## Block 1 - Cinema

**Block 1 - Cinema**

## Block 2

Block 1 (cinema) - Proposed east elevation

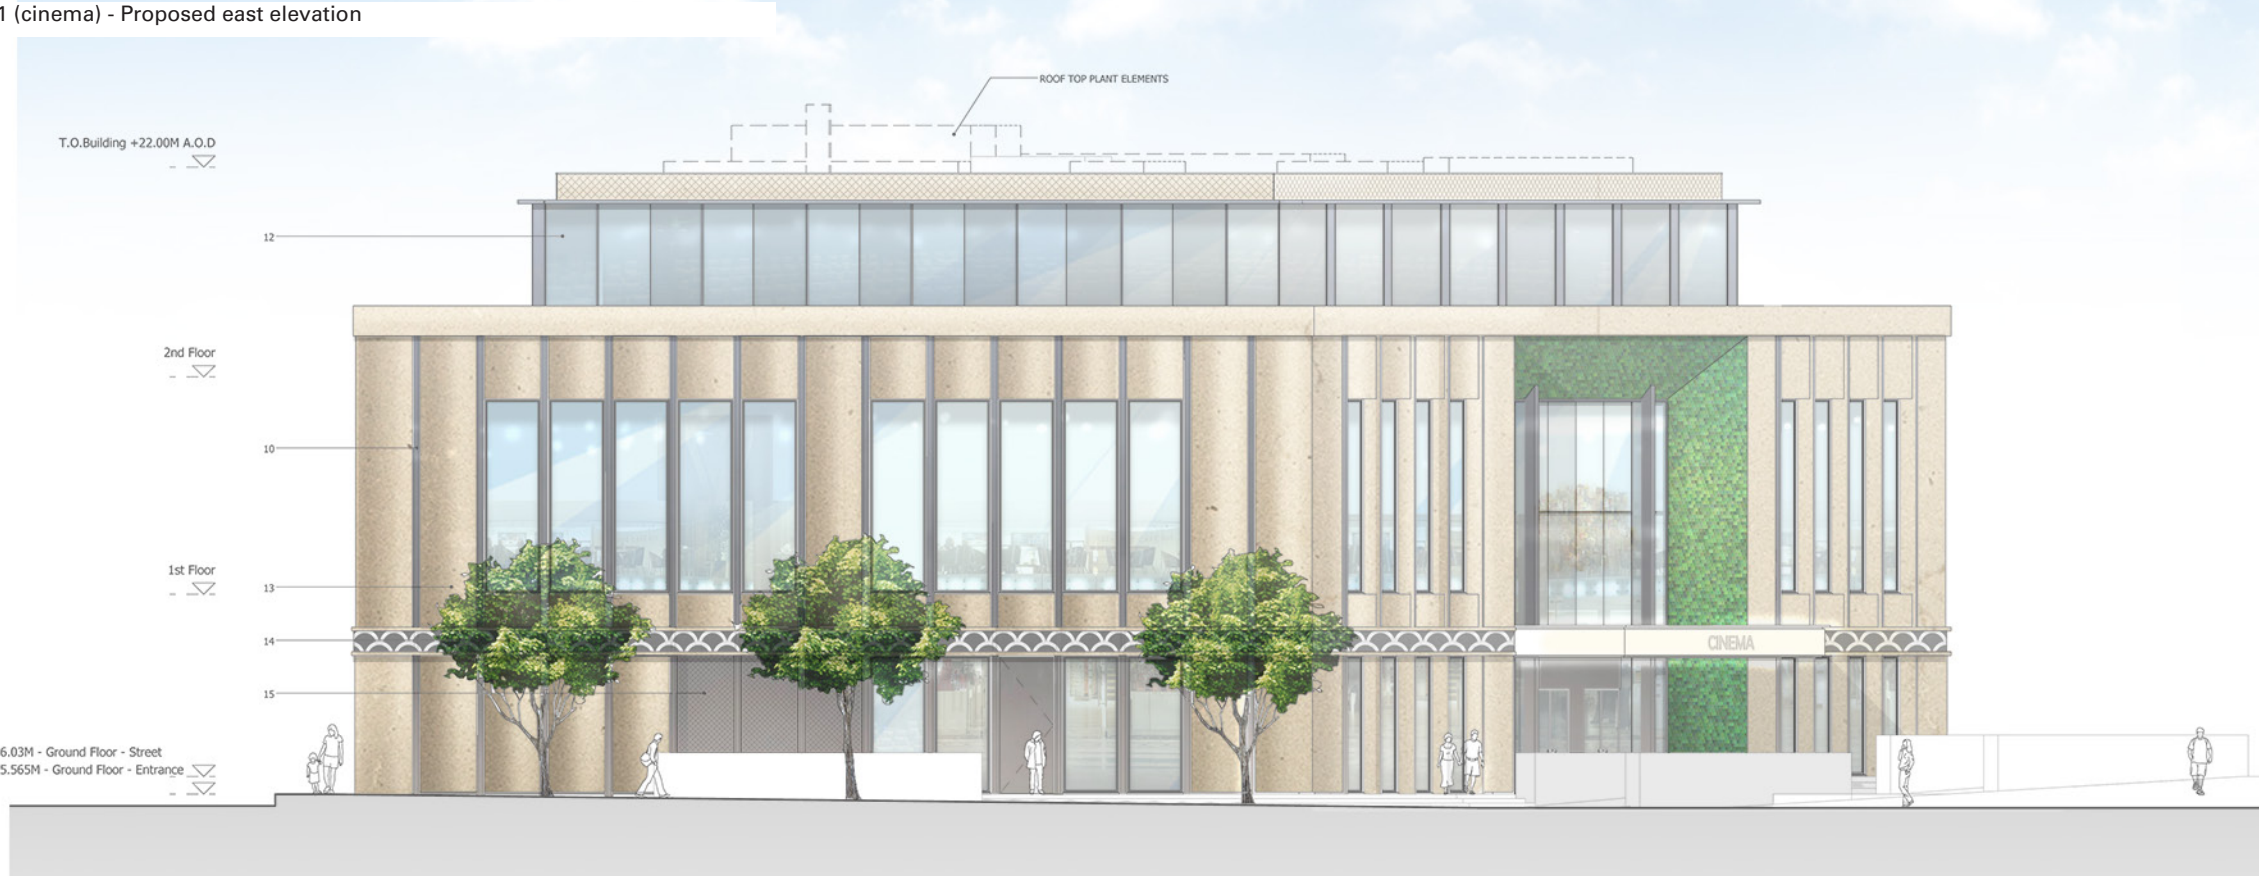
### 5. Relocate the entrance of the cinema.

The entrance to the cinema has been deliberately located on the east location to benefit from a more generous spill out space and to serve as an important civic gesture. We believe that relocating the entrance to face Lower Richmond Road would disrupt pedestrian flow along the pavement and increase the risk of pedestrians spilling on to the busy road. Aside from this, we do not believe this position would be as welcoming and prominent due to the angle of approach from the station through the park. Aside from these technical constraints, it is worth noting that an important design feature of the entrance is to have a double storey height angled reveal, which is proposed as being clad in a 'bottle green' coloured tile. This will be visually prominent in the views on approach from the station and village green.

Block 1 (cinema) - Proposed basement level plan

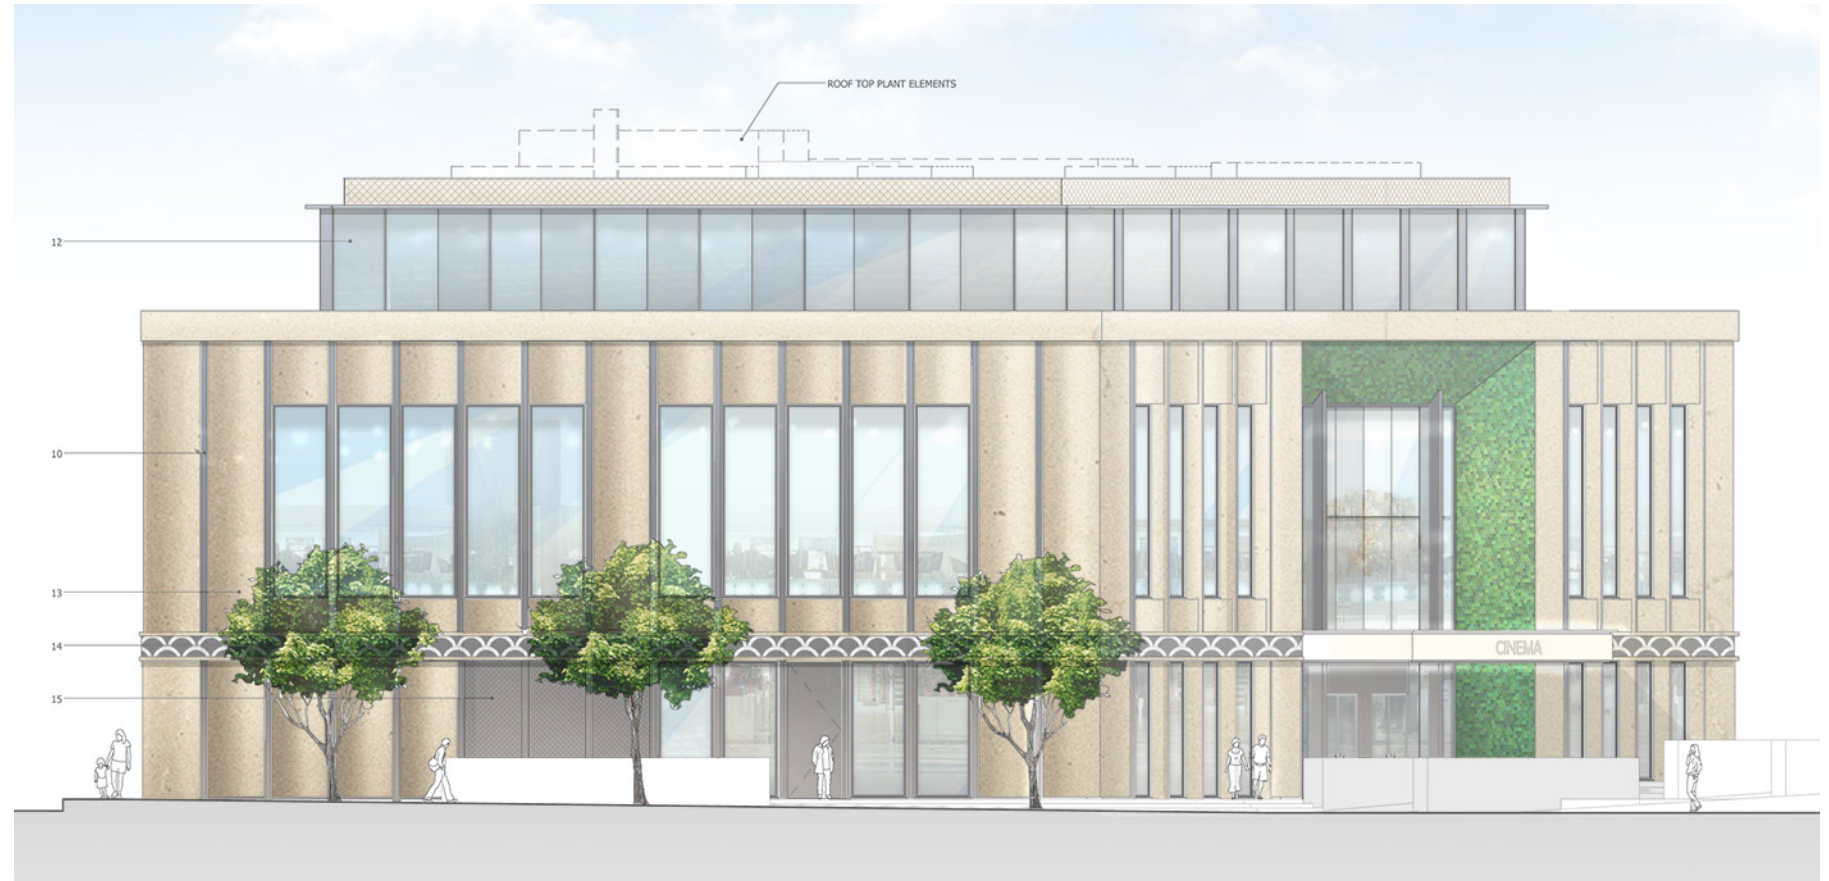
- 10. Cinema basement not shown on plan. Why can't the basement be lowered to provide level access?

Please see response to item 2. It is worth noting that the levels around the cinema facades vary, and that the internal level has been set to provide level access to the entrance on the East facade. The basement level consists of very small areas of basement - most of which are raked floors to cinema screens. These basement areas are not affecting the setting out of ground floor level datum.

Block 1 (cinema) - Proposed south elevation

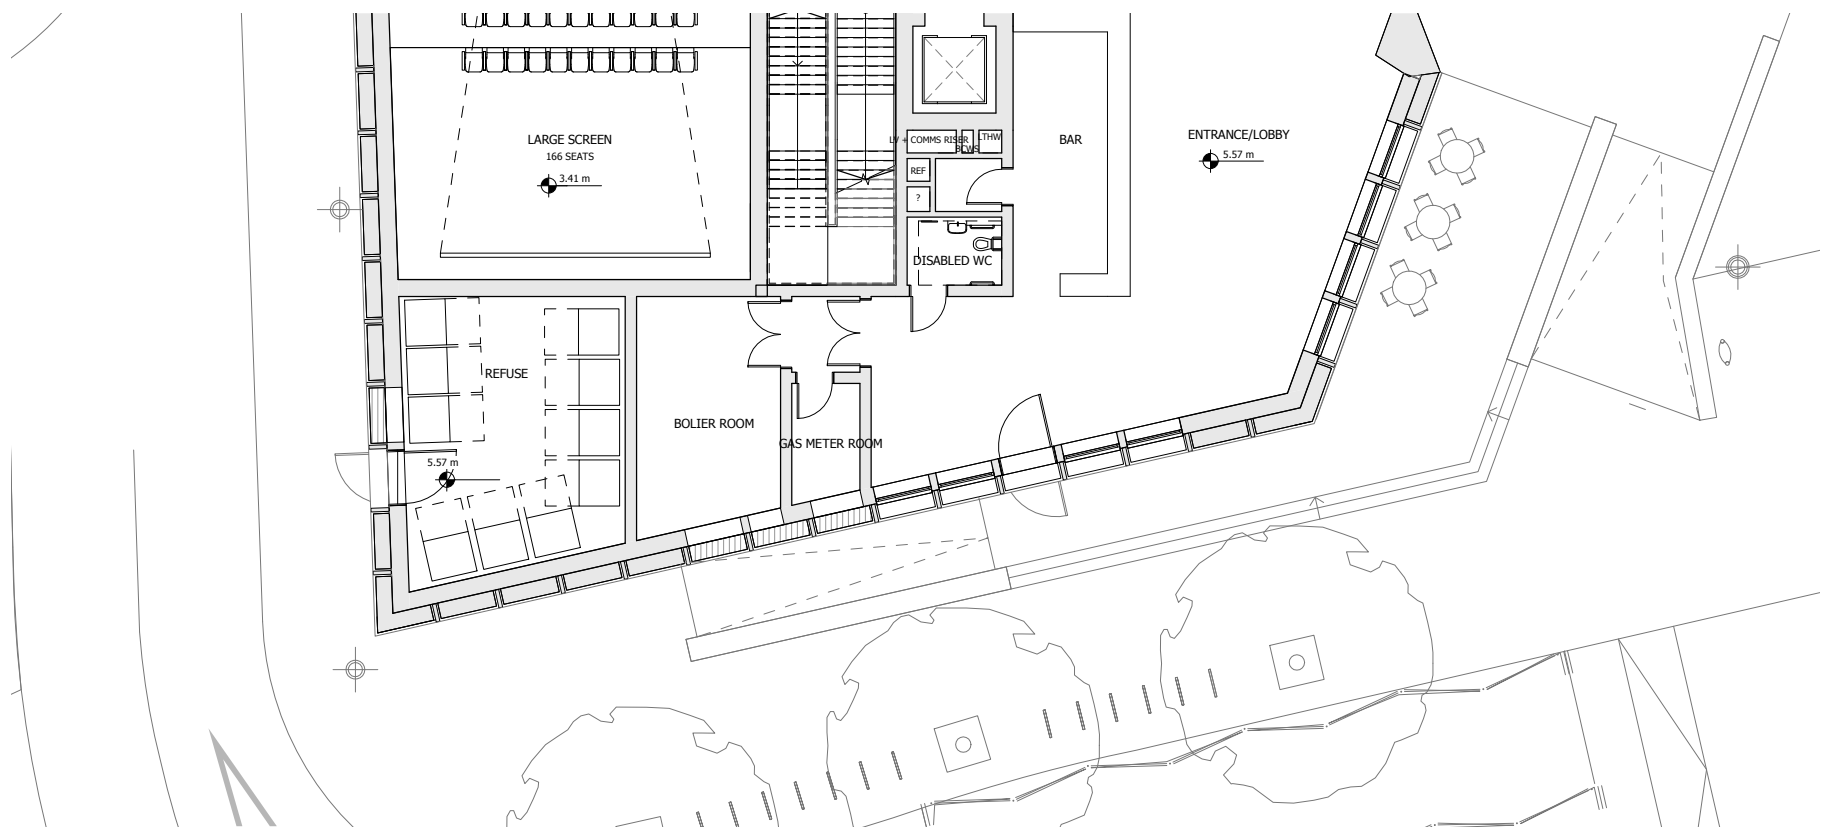
13. South elevation has a poor relationship with street: Refuse, boiler, second entrance.

14. As mentioned in earlier paragraphs, the cinema screens have been arranged to avoid overlooking issues with residential buildings opposite. These screen occupy most of the North and West facades. This leaves very little opportunity for the incorporation of refuse store and boiler rooms - which must have direct access from the street. The refuse cannot be collected from Lower Richmond Road since this would cause disruption to traffic. It is for this reason that it has been positioned on the corner of Ship Lane. The boiler room requires ventilation and must be positioned on a facade - it must also be positioned in a location where the flue can terminate in the set back rooftop level and so that service routes can be distributed easily to both cinema screens. It is for this reason that the North facade was discounted as a suitable location.

Revised view of corner elements to Buildings 2 and 7 (facing the entrance to the green link)

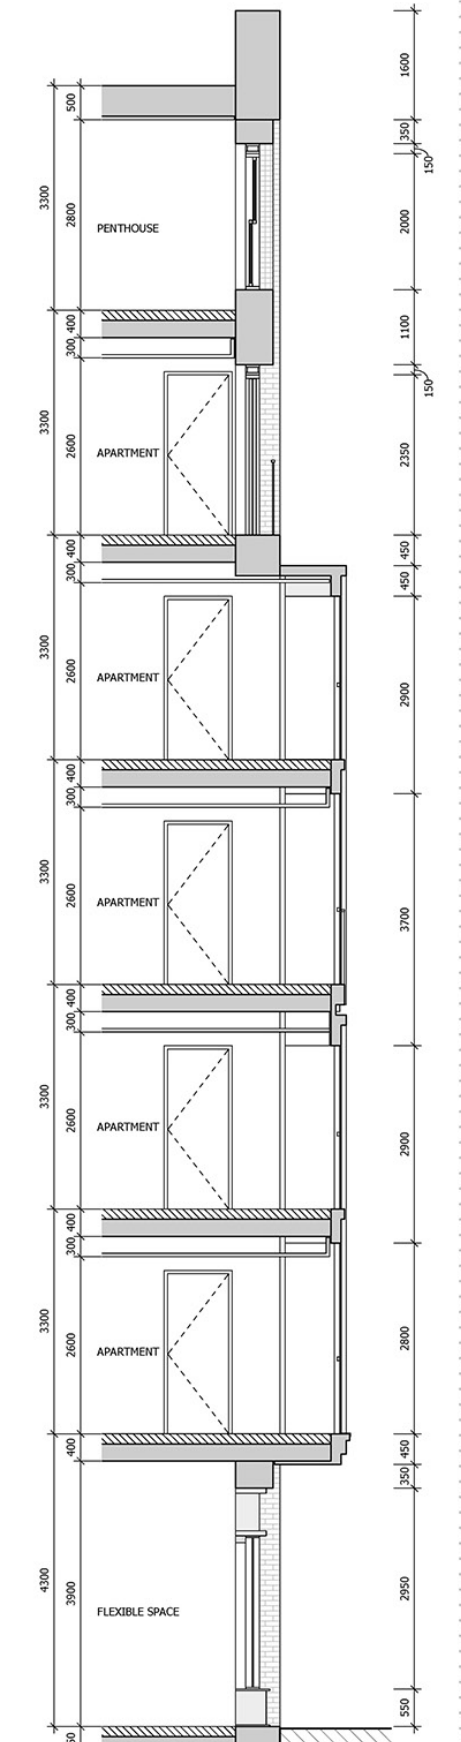
### 1. Turret needs refinement/ elegance

Corner 'turrets' are proposed to three strategic corners of mansion buildings. These elements aim to draw from historic precedent in terms of their design as well as serve as welcoming gateways elements that frame the view of the green link.

Each of the turret elements on buildings 2, 7 and 8 have been re-considered to provide hierarchy of window openings and a more refined top to the building - the result being an appearance more akin to historic precedents of mansion turrets that were built during the Victorian era across London.
